MEMORANDUM

**Re: Adequacy Review of Exhibit 6.5 – Geotechnical Stability Adequacy Response
Aggregate Industries; Tucson South Resource; File No. M-2004-044; AM-01**

The Division of Reclamation, Mining and Safety (Division/DRMS) has reviewed the Slope Stability Analysis adequacy response by Tetra Tech dated July 3, 2019 for the Tucson South Resource 112c permit amendment application (AM-01). The Applicant will need to address the following adequacy items identified in the review:

Project Tucson South AM
J-1 - Static

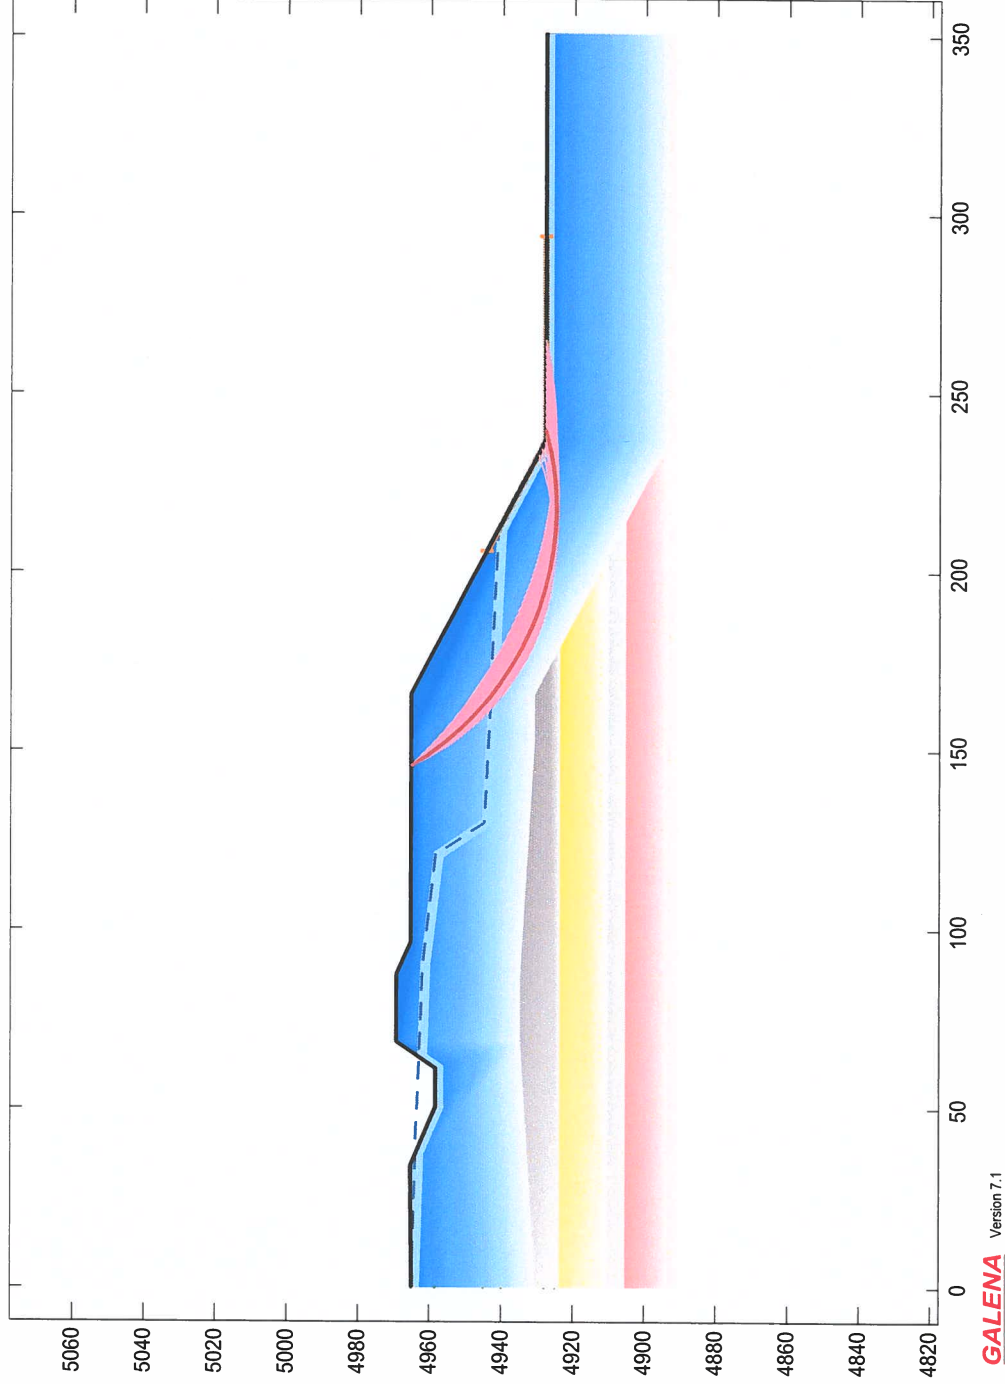
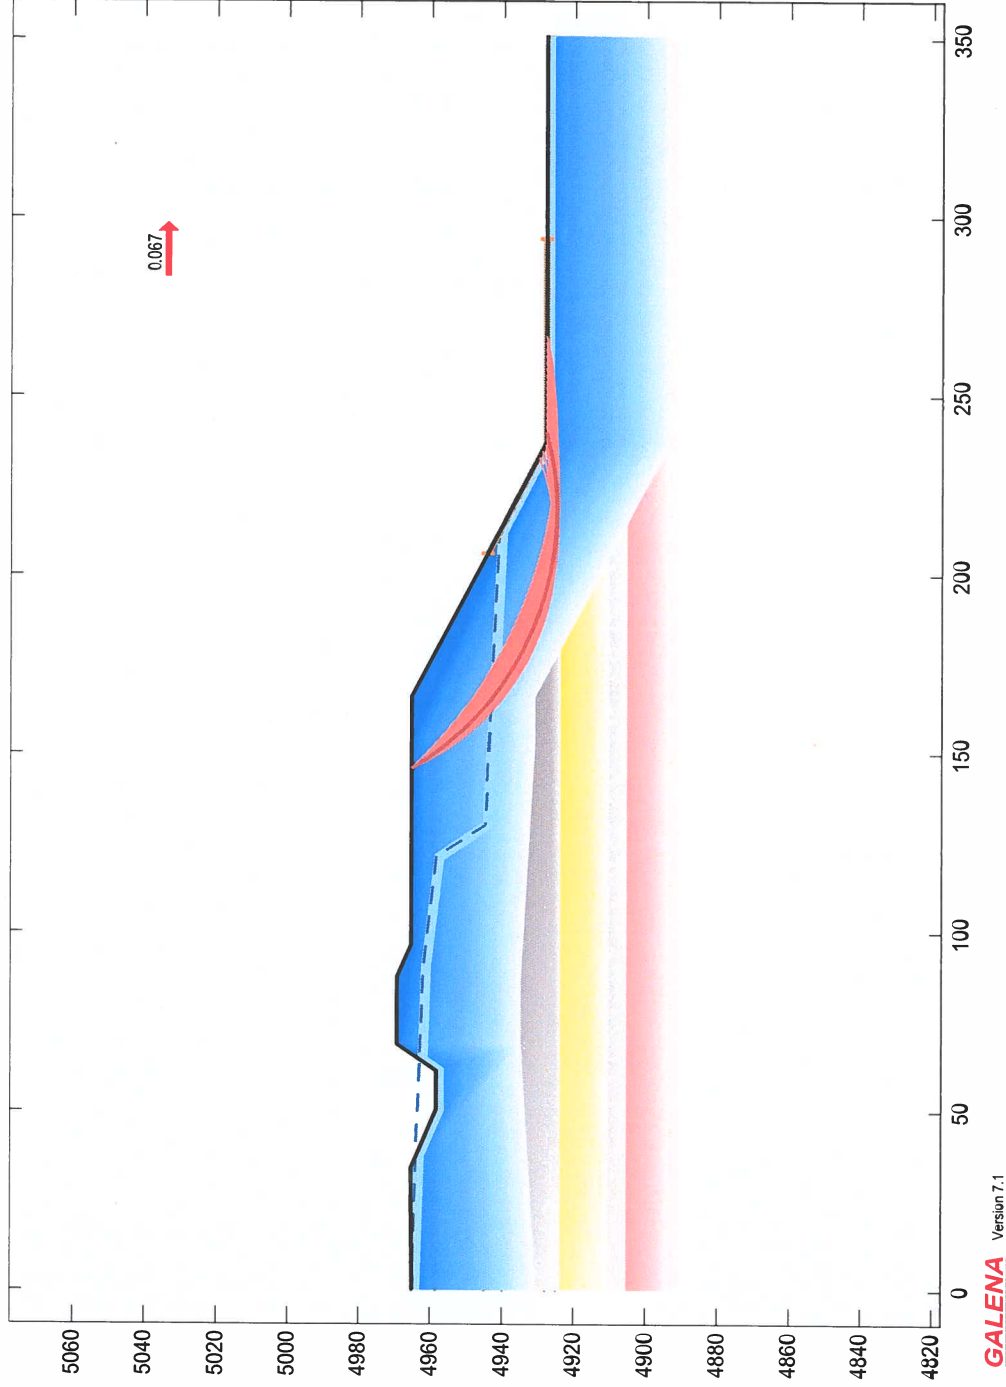
6. The Applicant modeled the Figure J analysis which produced a minimum FOS located 44 feet from the edge of the Brighton Return Ditch. The Exhibit C-3 Map indicates the Applicant modeled a 77 feet offset. Please explain this discrepancy and revise the Figure J models and/or the Exhibit C-3 Map accordingly.

The Division duplicated the Figure J models with the 77 feet offset from the edge of the Brighton Return Ditch. The models produced factors of safety of 1.07 – Static and 0.89 – Pseudostatic, which do not meet the required FOS. Please review the Applicant's and Division's models and reevaluate the proposed offset distance from the Brighton Return Ditch to conform to the FOS requirement of the MLRB.
